# PERFORMANCE BULLETIN

March 20, 2000

## 2310 Safety Brine Valve Material Changes

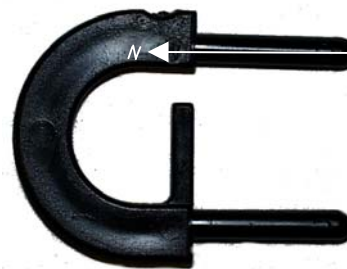
The material of the 2310 valve drain retainer (part #18312) was changed from Acetyl to Noryl in May '99 because of chemical attack. The new Noryl retainer can be identified by a capital "N" on one side of the retainer. See details in the photo below.

The "N" is indicated here in white, for illustration purposes only. It is actually the same color as the retainer.
